How to update T32MZ

This software updates or alters the functions and features noted below. The instructions and information that follow are meant as a supplement to the original instruction manual that accompanied the T32MZ transmitter. Please refer to the original instruction manual where applicable, but replace the steps indicated below with these instructions. Please note that the software update will be finalized the first time that the T32MZ is powered up, after the software has been applied. As such, it may require a few moments before the Start screen appears. Please check to ensure that the update has been installed.

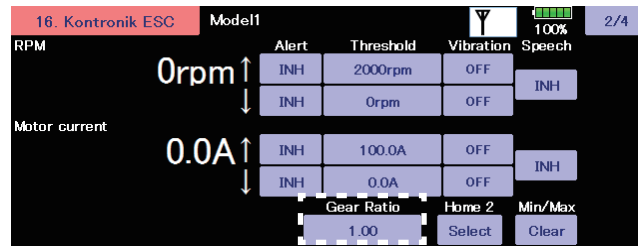
1. Telemetry settings: Added gear ratio setting button to Kontronik ESC and Scorpion ESC.

•If the gear is down, enter the gear ratio to display the helicopter rotor speed and the airplane gear down propeller speed.

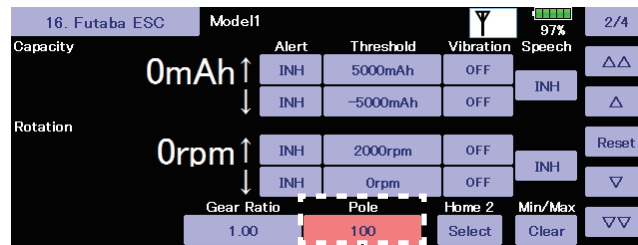
2. Telemetry settings: Changed the motor pole number setting for each ESC to "100".

Previously, the number of poles was up to 36, but now it can be set up to 100.

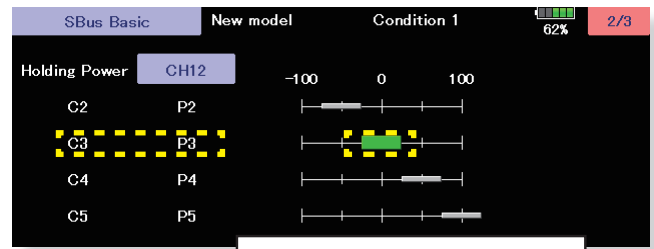
- 1. CH3 (THR) can be output to the RUD2 / S.BUS2 port.
- 2. The Holding Power rate of the aircraft in AVCS mode has been expanded to 5 types from C1 to C5, and each rate can be set by switching the display.
- 3. Added the setting of switching CH of Holding Power rate C1 to C5 to S.BUS basic menu.

Added CH3 (THR) to the output item of RUD2 / S.BUS port

Added the setting of switching CH of holding power rate C1 to C5 to S.BUS basic menu.

◆ S.BUS Basic screen The second page has been added, and the total number of pages has changed from 2 to 3.

2. Add R.P.M. display : Gov Basic

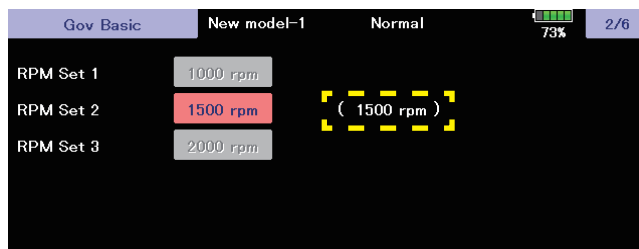
The number of revolutions of the governor setting is displayed on the governor basic screen of the gyro setting.

3. GYA553 Addition of setting parameters

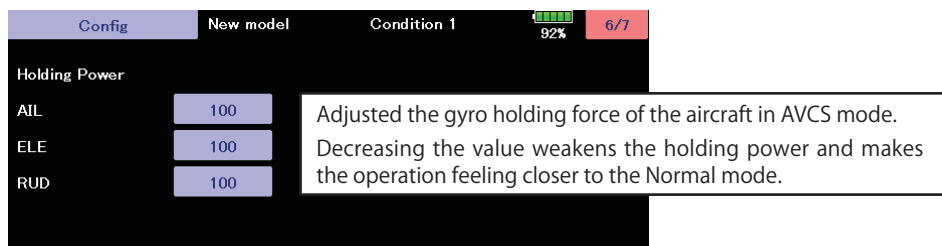
AIL / ELE / RUD holding power setting has been added to the setting parameters of GYA553.

4. Expansion of governor R.P.M. range

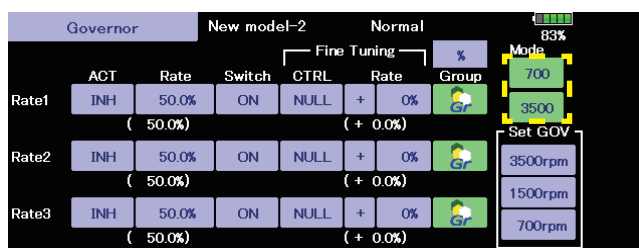
With the governor function of the model menu, the R.P.M. range has been expanded to 700 to 3500 rpm.
